CITY of NOVI CITY COUNCIL

Agenda Item J

SUBJECT: Approval of a request from Mirage Development, LLC for a variance from the following ordinance sections: 1) Subdivision Ordinance Section 4.05(A) requiring that pedestrian safety paths be constructed along both sides of local streets (a sidewalk on only the north side is proposed), 2) Section 11-94(c) to provide less than three feet of cover for storm sewer pipe, 3) Section 11-194(a)(7) for exceeding the 800-foot maximum length of a cul-de-sac (975 feet is proposed), and 4) Section 11-194(a)(19) for the lack of a secondary or emergency access; as part of the site plan for Orchard Hills North single family residential development (parcel 22-26-201-006).

Re: Orchard Hills North
Variances from Design and Construction Standards

VARIANCE REQUESTS PLAN

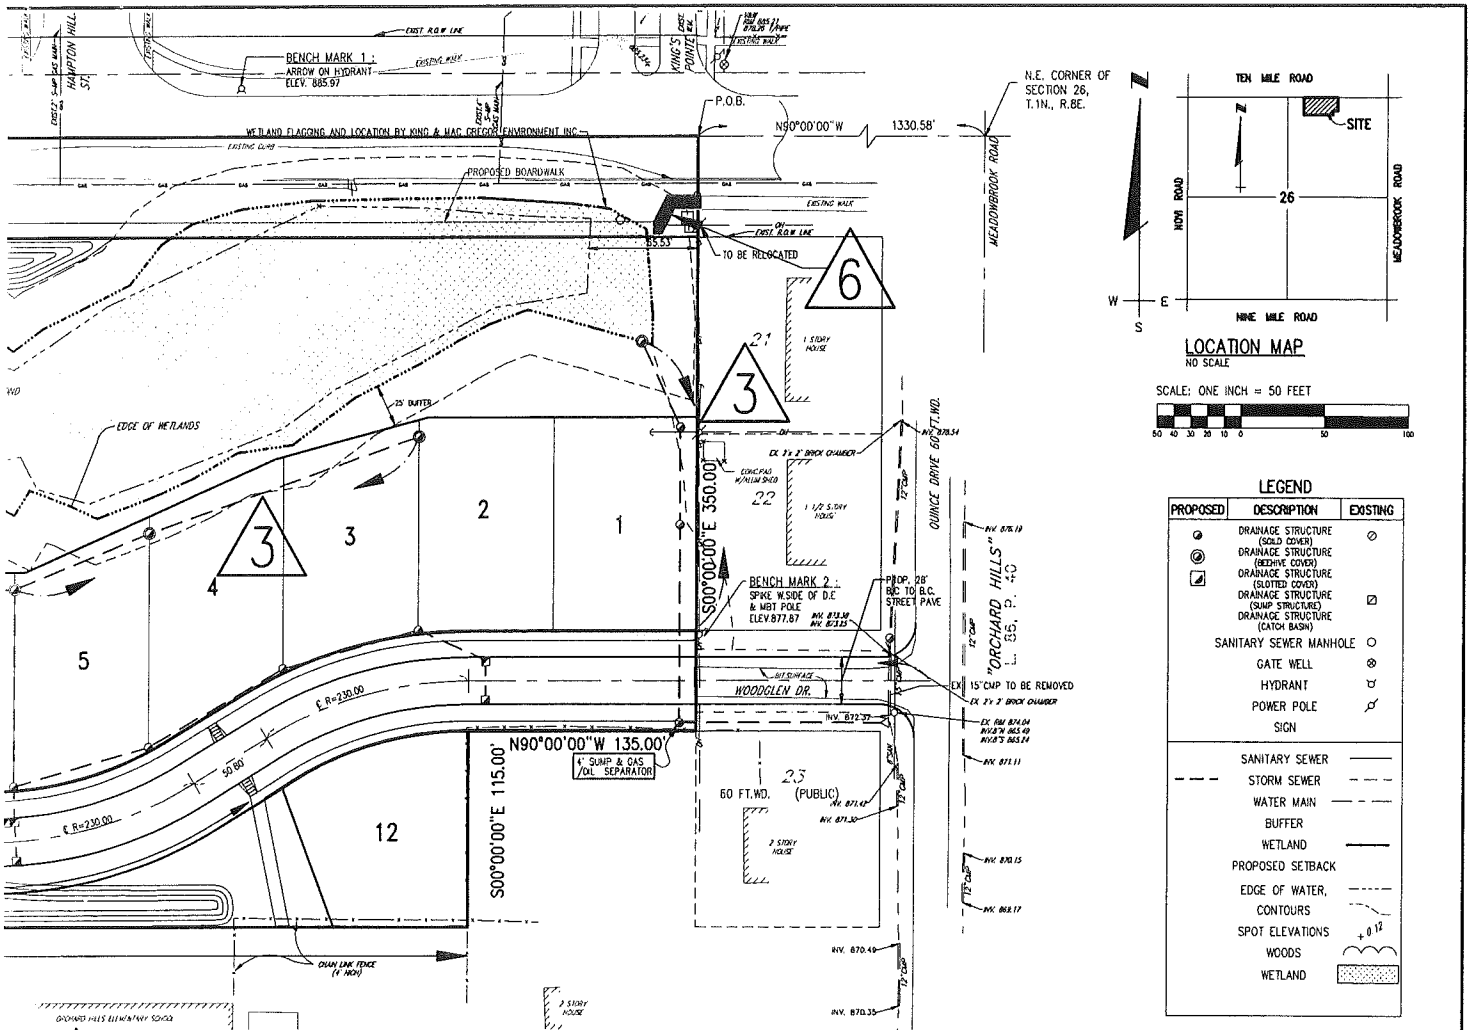
- 1** A City Council waiver for having a sidewalk on only one side of Woodglen Street:

- 2** An administrative variance from Appendix C, Section 4.04(A)(1) for not providing stub street to adjacent school property.

- 3** A City Council variance is requested from Section 11-94(C) for providing less than three feet of cover for storm sewer pipe.

- 4** A variance is requested from City Council from Section 11-194(a)(7) for exceeding the 800 foot maximum length for a cul de sac.

A variance is requested from City Council from Section 11-194(a)(19) for units in excess of 800 feet external access.

A variance is requested from City Council from Section 11-258(a) for a bicycle path more than (1) foot away from future right-of-way lines.
